Parts Bulletin

Group	Number	Version
P-27-6	2	01

End of Production - Stop Cables

Models: Accessories

[Fig. 1]

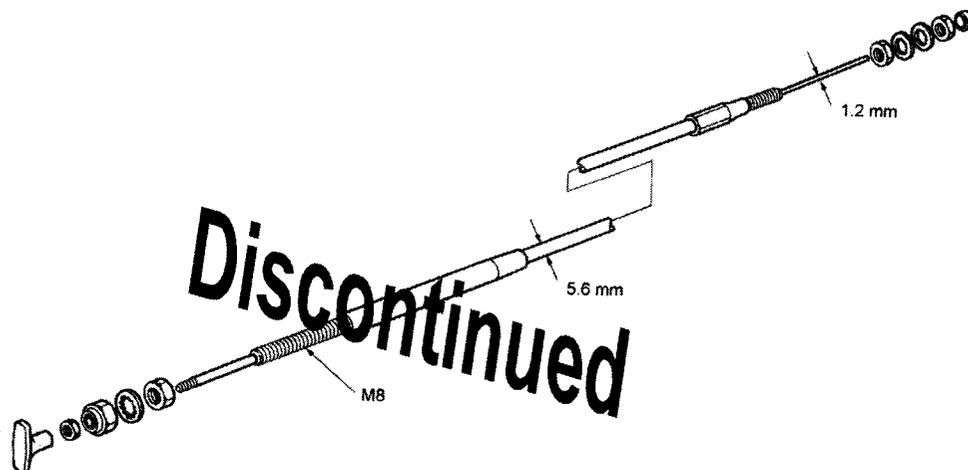
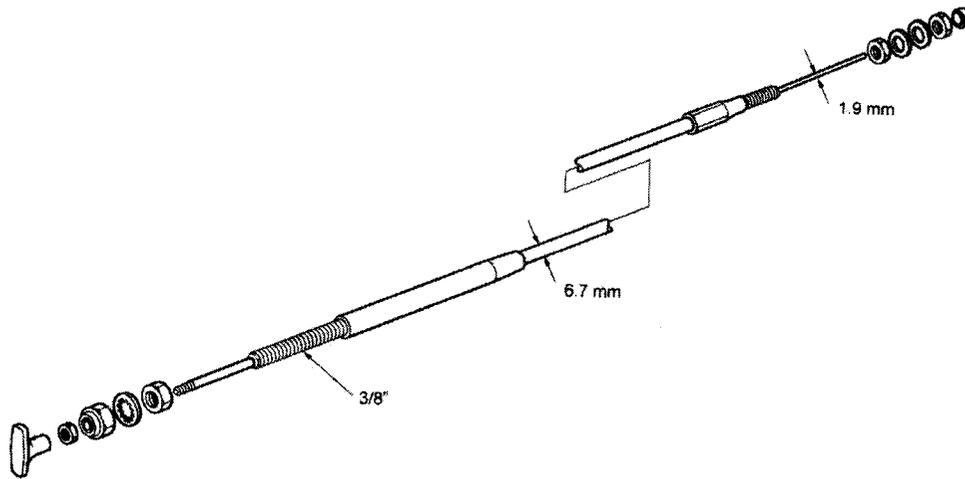
Important notice though is that the new cable will now follow the marine industry standard which means that it will be a cable with slightly different geometry and properties.

825764 & 825765 have a core diameter of 1.2 mm inner cable/piano wire and a conduit diameter of 5.6 mm. (See fig. 1 below)

These cables accept a minimum bending radius of 150 mm.

The replacement cables have a core diameter of 1.9 mm inner cable/piano wire and a conduit diameter of 6.7 mm. (See fig. 2 below)

These cables accept a minimum bending radius of 200 mm.

New part numbers are:
21272376 - 3.3 meters
21272378 - 6.9 meters

General guidelines regarding mechanical cables and wires are to keep any bending radiuses as large as practically possible, and loosely clamp the cable at appropriate locations along the routing, but it's important not to jam the cable, since it might compromise its function.
